24250-01-001

**RESIDENTIAL DEVELOPMENT,  
BALLYHASKEY, NEWTOWNCUNNINGHAM,  
COUNTY DONEGAL**

Road Safety Audit Stage 1

**DONEGAL COUNTY COUNCIL**

2.3 **Problem:** Reversing from Cul-de-sacs  
**Location:** Adjacent to House No. 1 and 8

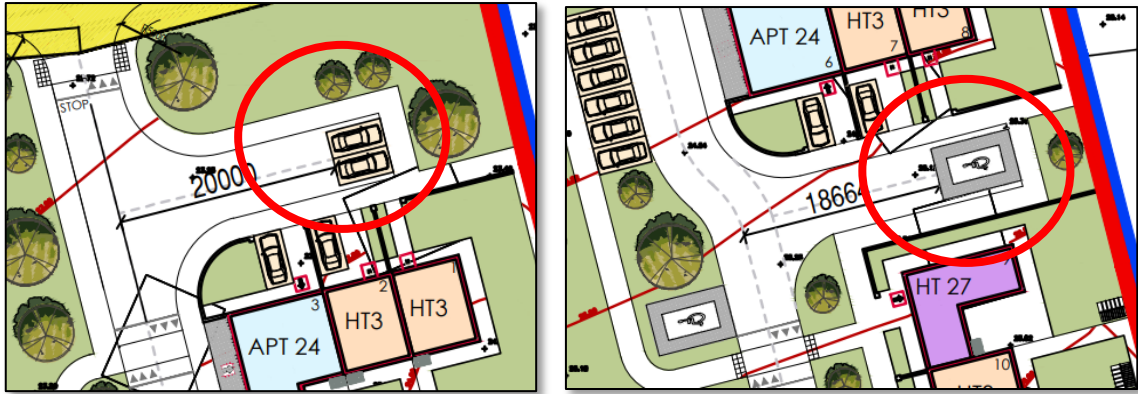
The design drawing indicates parking bays at the end of cul-de-sacs adjacent to house No. 1 and 8. The position and layout of these bays may result in a motorist having to reverse into or out of the bay over a substantial distance. Such a manoeuvre may increase collision risk within the proposed development.

**Recommendation:** Ensure that the layout of parking bays does not lead to motorists reversing over long distances when entering or exiting.

2.4 **Problem:** Disabled Parking Access  
**Location:** Across from No. 9

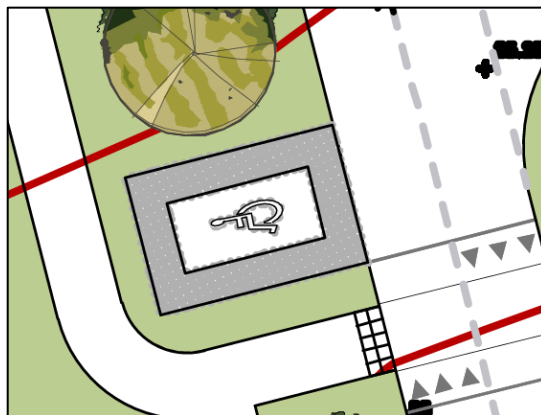
A disabled car parking space is located at the western side of the access road, however access to the footpath from the bay is across a grassed area. Mobility impaired pedestrians using these car parking spaces will have to travel through the grassed area where they may be a likelihood of slips and fall or across the access road where they will be at an increased risk of being struck by a passing vehicle

**Recommendation:** Ensure disabled motorists can safely access the footpaths from the disabled parking bay.

**2.5 Problem:** Pedestrians Crossing at Unsafe Locations**Location:** Western Side of the Access Road

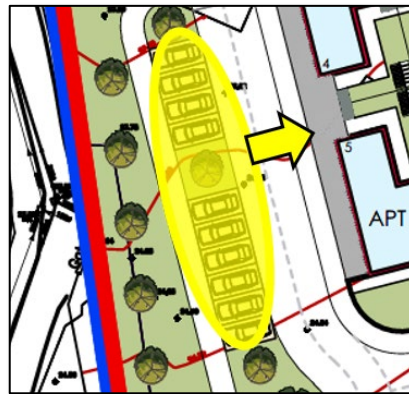
A pedestrian crossing is proposed at house no. 3, however, the location of the crossing does not cater for the desired route of pedestrians who are parking on the western side of the access road. A lack of crossing facilities to cater for pedestrian desire lines may lead to pedestrians crossing at full height kerb/unsafe locations. This may increase the risk of pedestrian and vehicle collisions.

**Recommendation:** Revise the location of the pedestrian crossings at this location to ensure that the desired line for pedestrians is catered for.

**2.6 Problem:** Pedestrian/Motorist Intervisibility**Location:** House No. 15

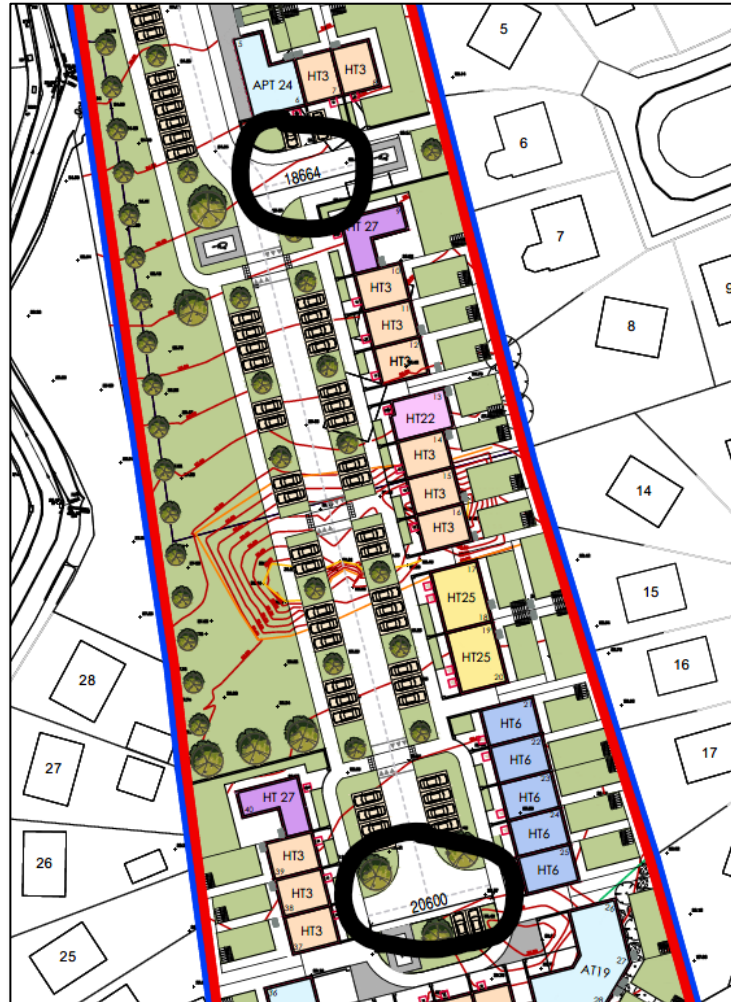
A pedestrian crossing is indicated adjacent to house number 15. Car parking bays are indicated either side of the crossing. When vehicles are parked in these bays, it is unclear whether adequate inter-visibility is provided between motorists approaching the pedestrian crossing and pedestrians stopped waiting to cross. While this pedestrian crossing has particularly been highlighted, inter-visibility may also be similarly restricted at other pedestrian crossing locations.

**Recommendation:** Ensure that adequate inter-visibility splays are provided at all pedestrian crossing locations.

**2.9 Problem: Pedestrians Crossing at Unsafe Locations****Location:** Adjacent to House No. 3 and 6

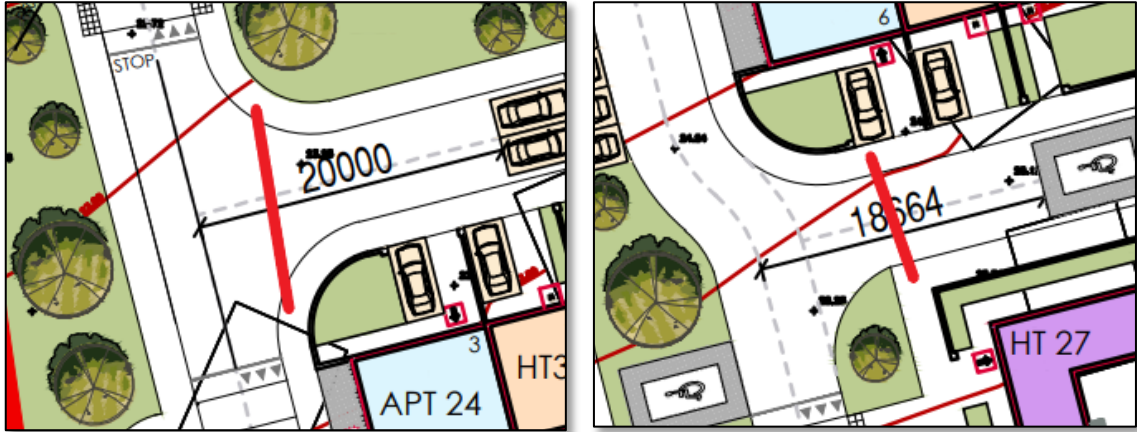
A pedestrian footpath is indicated around the cul-de-sacs; however, its placement does not align with the preferred path for pedestrians. Insufficient crossing facilities along pedestrian desire lines could result in individuals crossing at full-height kerbs or unsafe areas.

**Recommendation:** Revise the layout of the footpaths to ensure that the desired crossing line for pedestrians is catered for.
